The only visible difference in the beacon body will be looking into the transparent dome moulding:

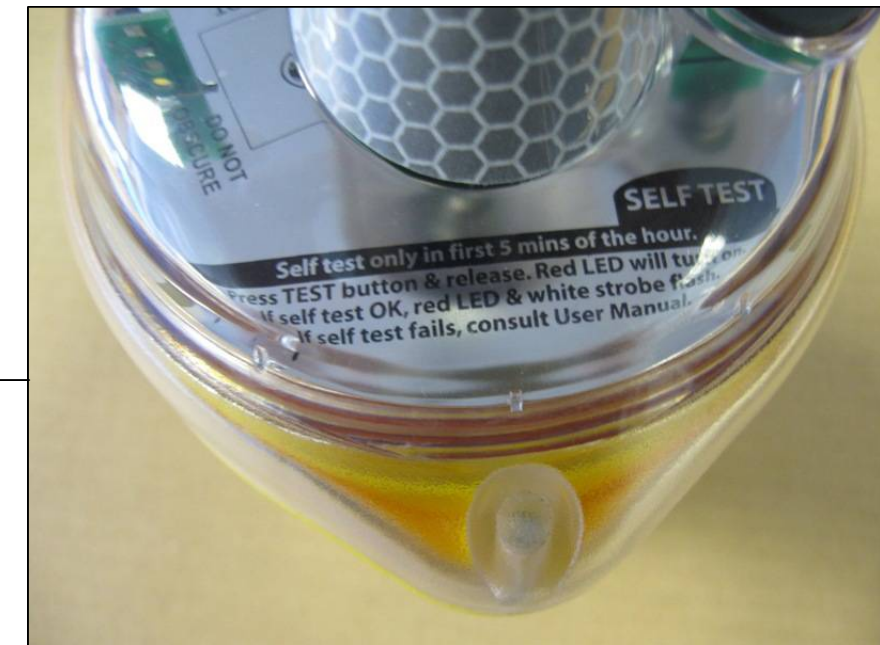
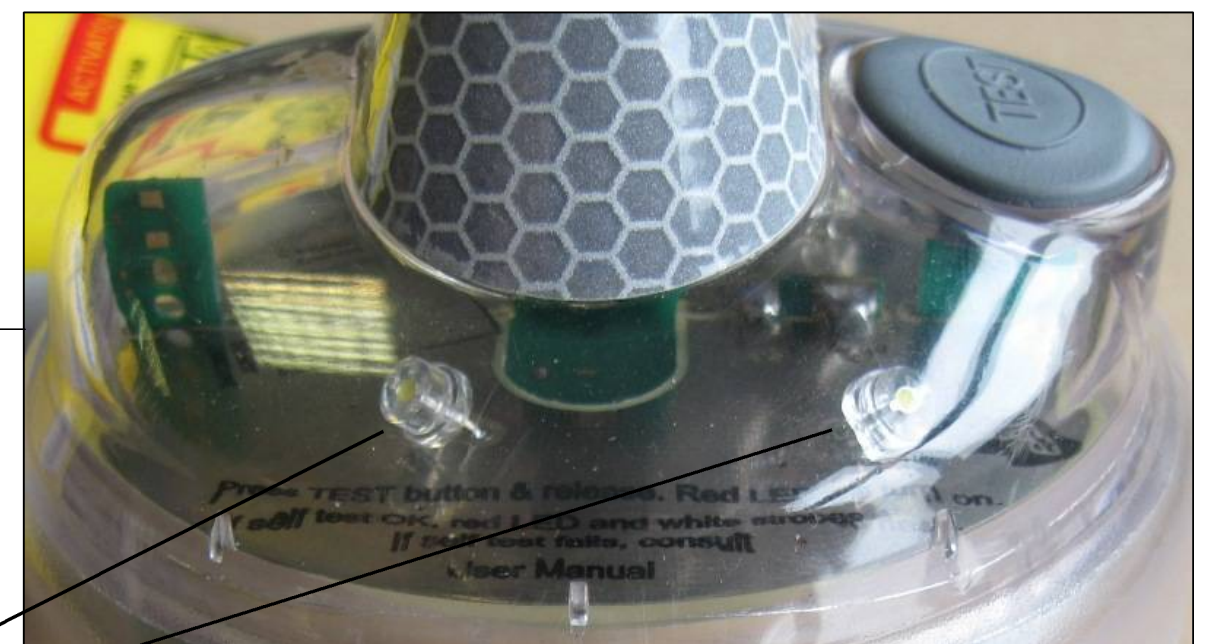
Four LEDs replace the single LED with lens for the Low-Duty-Cycle-Light function

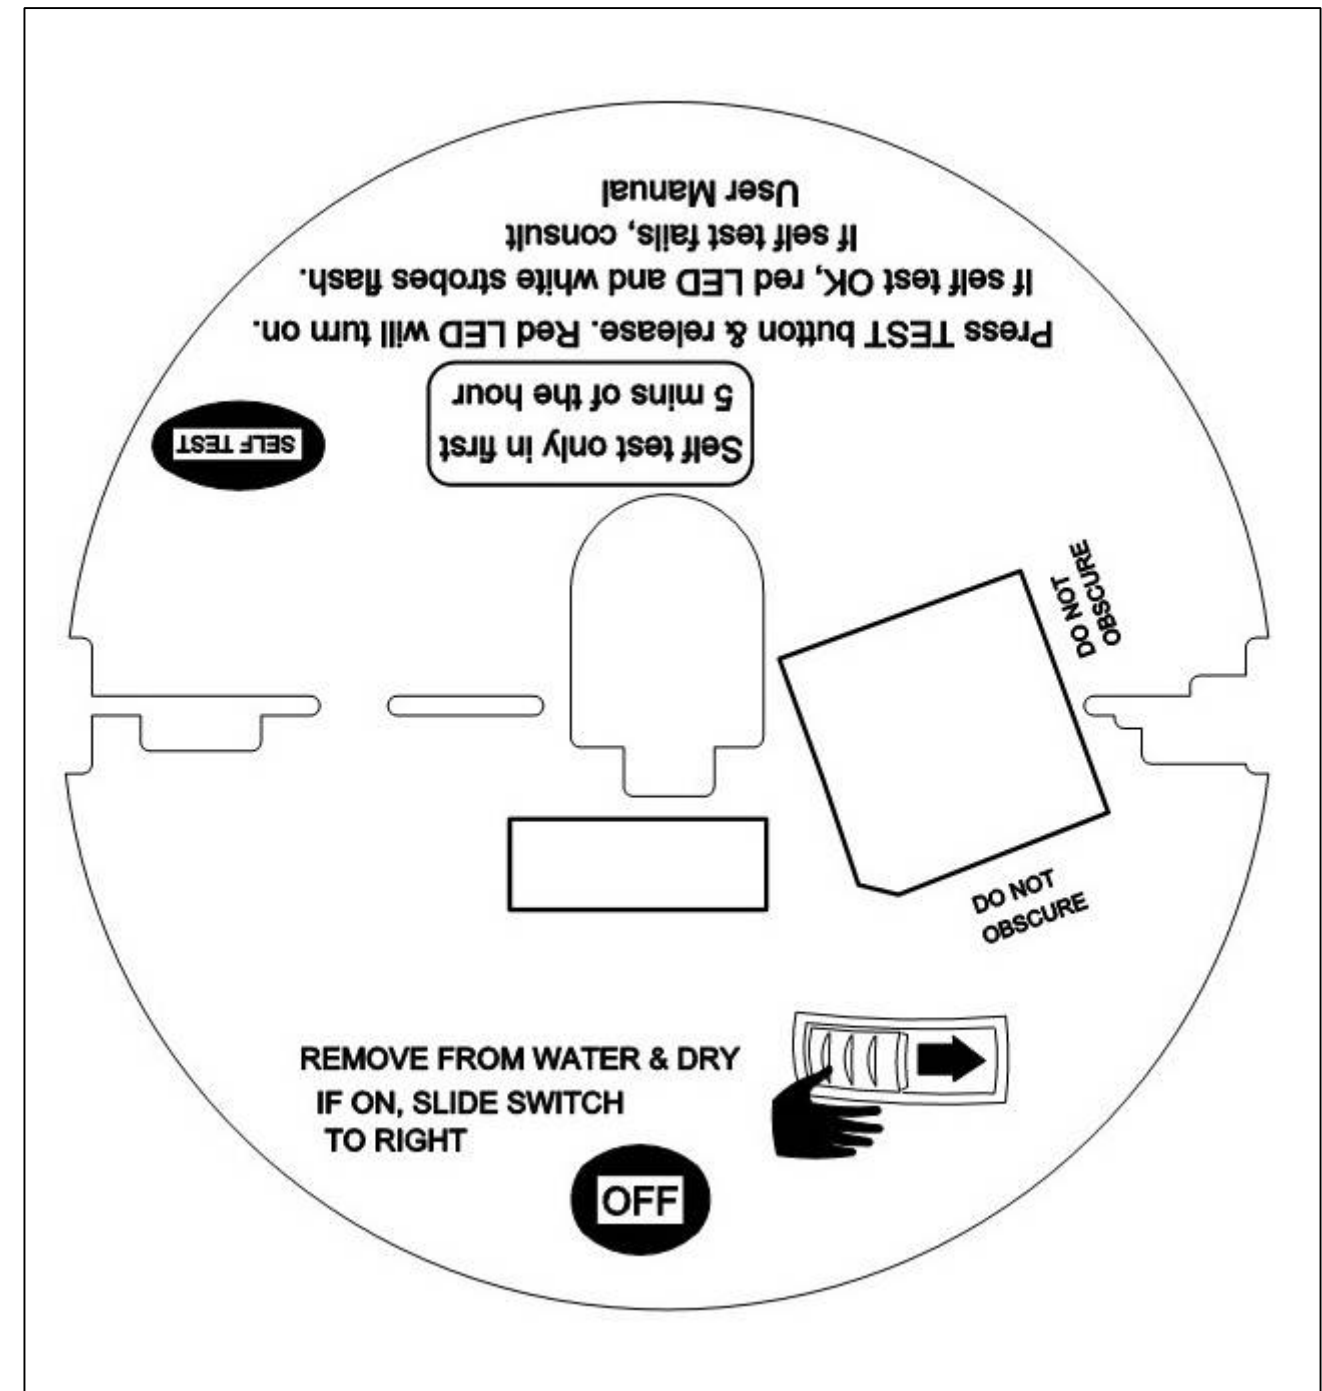
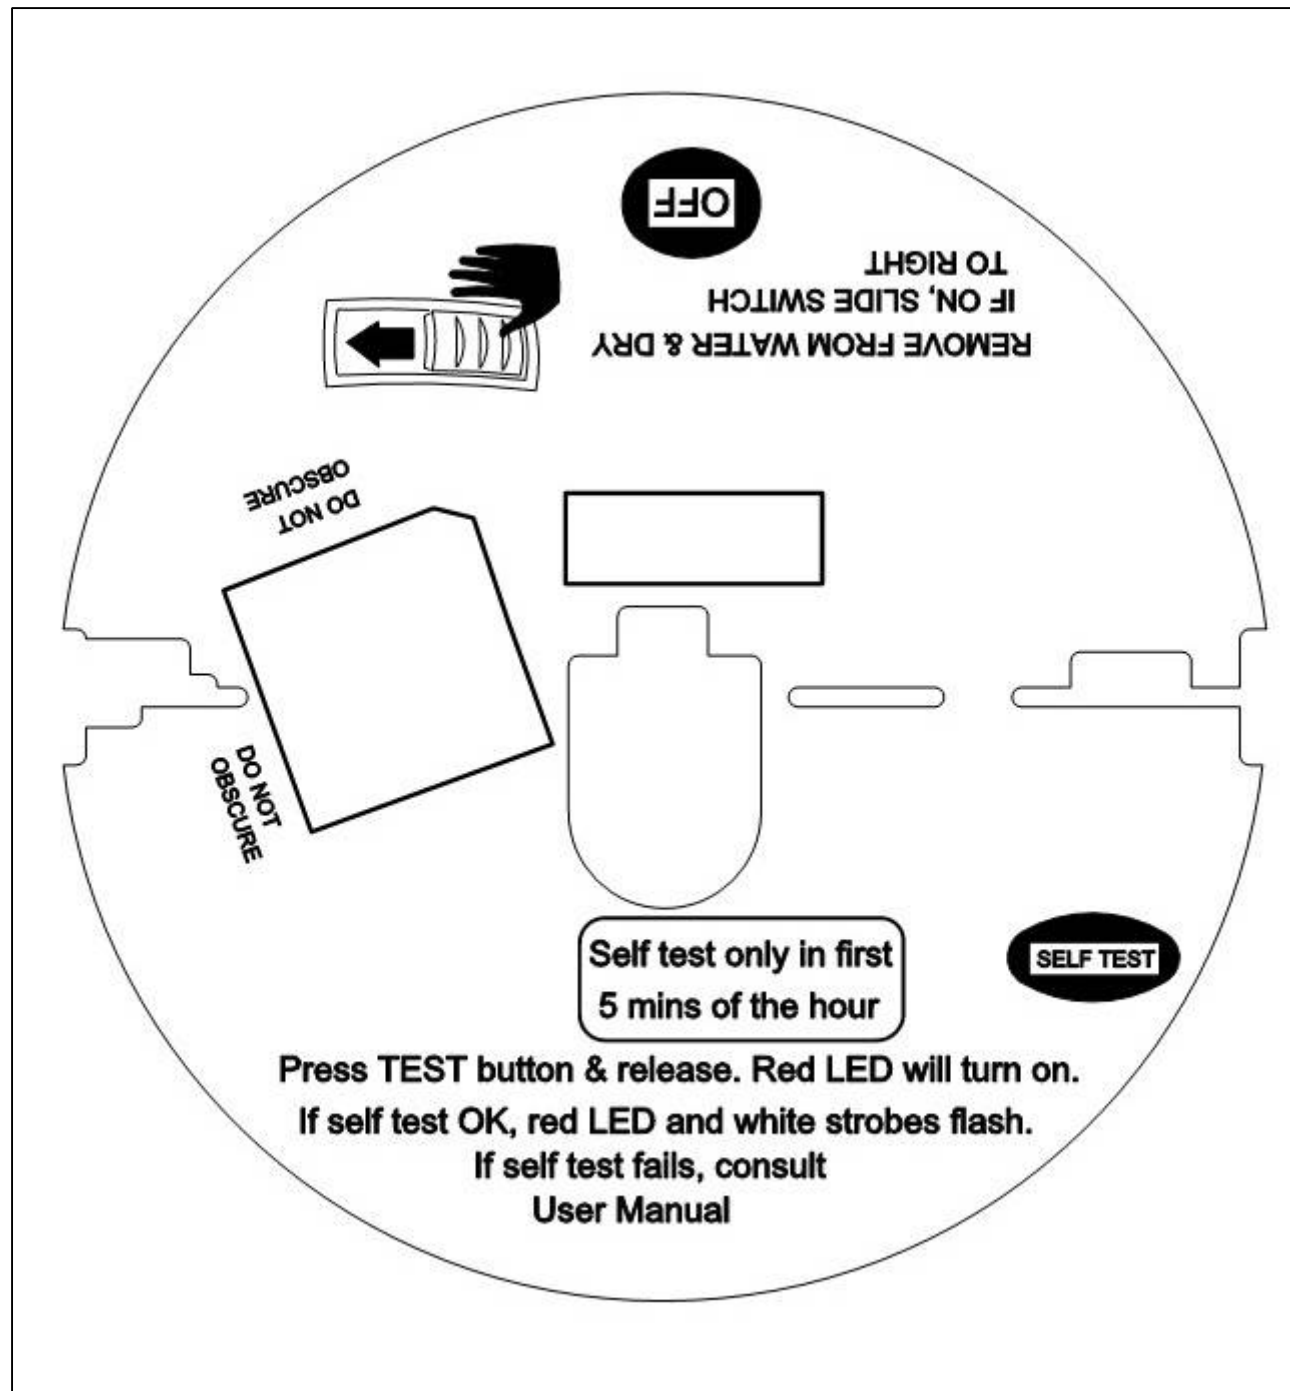
The E5-2 Build images above are from the test prototype - the top silkscreen for the production version of the disc PCB is shown below, to better illustrate the legend which will be visible looking into the transparent dome moulding:
